SUBJECT: Caution about not mixing different size originals with DF-43

AD-1

Model: AD1 (DF43)		Date: 28-Feb-97	No: 019	1/2
Subject: Black stripes			Prepared by: K. Ugaeri	
From: QAC 2nd Field Information Dept .			Checked by: S. Fujii <i>T. Inoue</i>	
Classification:	<input checked="" type="checkbox"/> Troubleshooting <input type="checkbox"/> Part information <input type="checkbox"/> Action required <input type="checkbox"/> Mechanical <input type="checkbox"/> Electrical <input type="checkbox"/> Service manual revision <input type="checkbox"/> Paper path <input type="checkbox"/> Transmit/receive <input type="checkbox"/> Retrofit information <input type="checkbox"/> Other ( )

Model: AD1 (DF43)		Date: 28-Feb-97	No: 022	1/1
Subject: Front Guide Plate and Rear Guide Plate			Prepared by: Horiike	
From: QAC 2nd Field Information Dept .			Checked by: S. Fujii	
Classification:	<input type="checkbox"/> Troubleshooting <input checked="" type="checkbox"/> Part information <input type="checkbox"/> Action required <input type="checkbox"/> Mechanical <input type="checkbox"/> Electrical <input type="checkbox"/> Service manual revision <input type="checkbox"/> Paper path <input type="checkbox"/> T

Fig.1

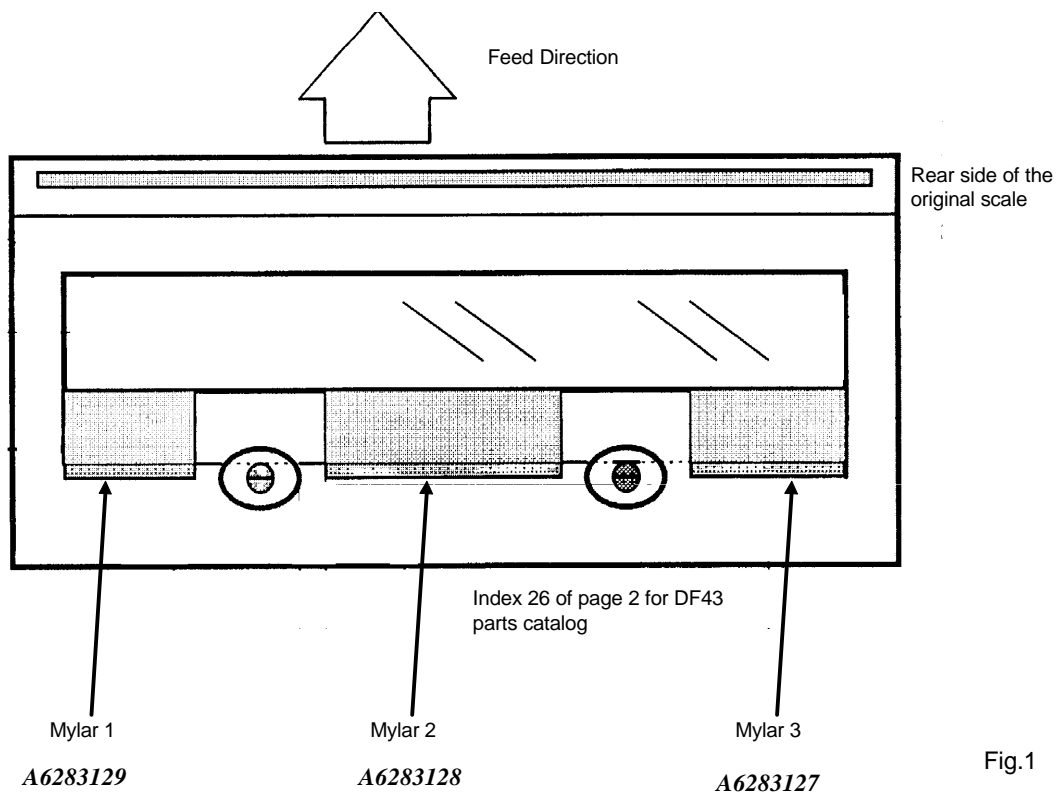
Black stripes when using the sheet scanner

Dust on the exposure glass.

1. The **three** mylars have been added on the original scale (A6283192) to prevent the scanning position on the exposure glass from becoming dirty.

Fig. 2

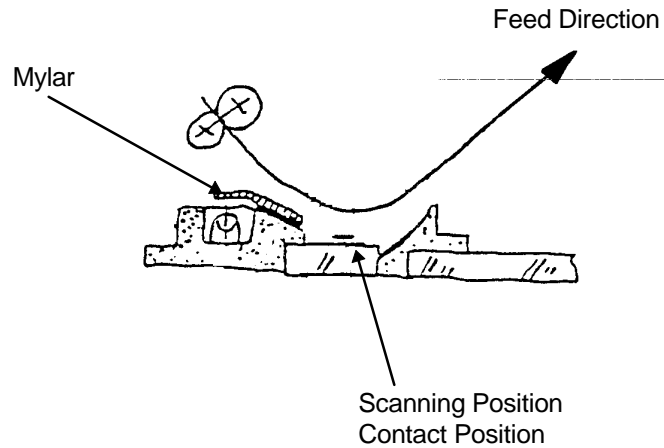
Because the contact position of the original becomes dirty with paper dust, it has been moved from the scanning position by using mylars.

Fig. 3

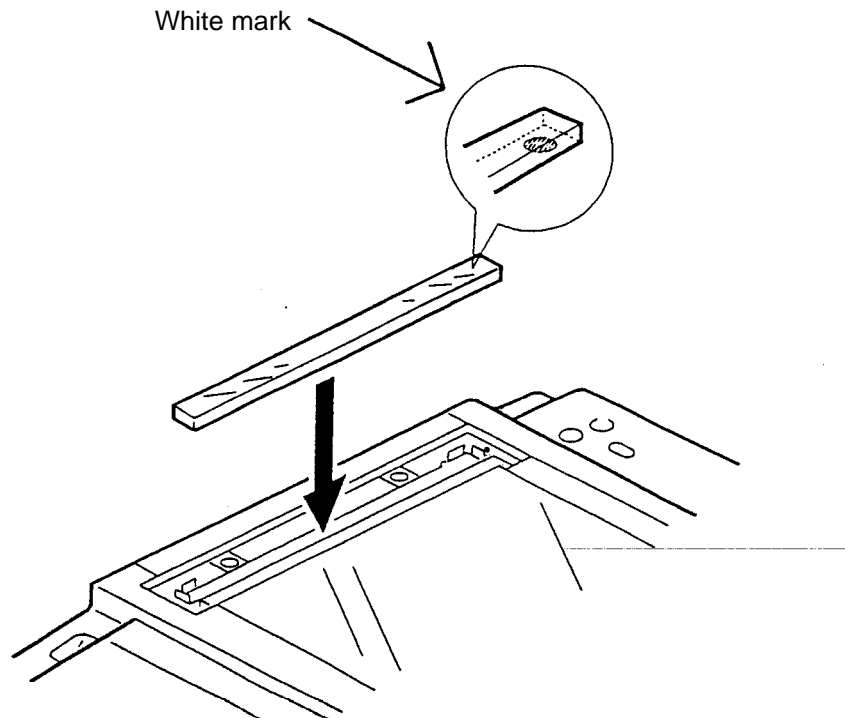
2. The surface of the exposure glass has been treated by the mater replant process.

Note: This exposure glass has a white mark. This mark must be at the bottom rear side at installation.

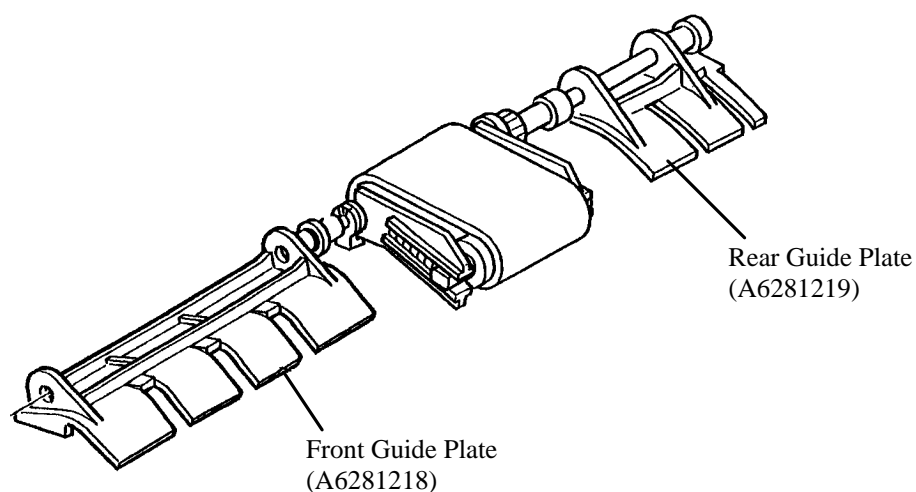
The left cover cannot be closed.

The Front or Rear Guide Plate was accidentally turned to the left when the operator removed a jammed original, because these plates are difficult to see.

The color of the Front and Rear Guide Plates has been changed from black to a clear color.

Current	New
Front Guide Plate	A628 1218B	A628 1218C
Rear Guide Plate	A628 1219B	A628 1219C

[Jam Removal Decal] A628 6031B → A6286031C

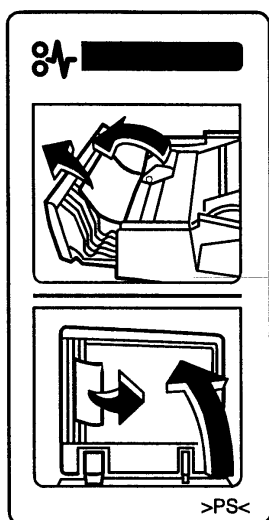
To make the removal procedure for a jammed original easier to understand, the drawing on the decal has been changed
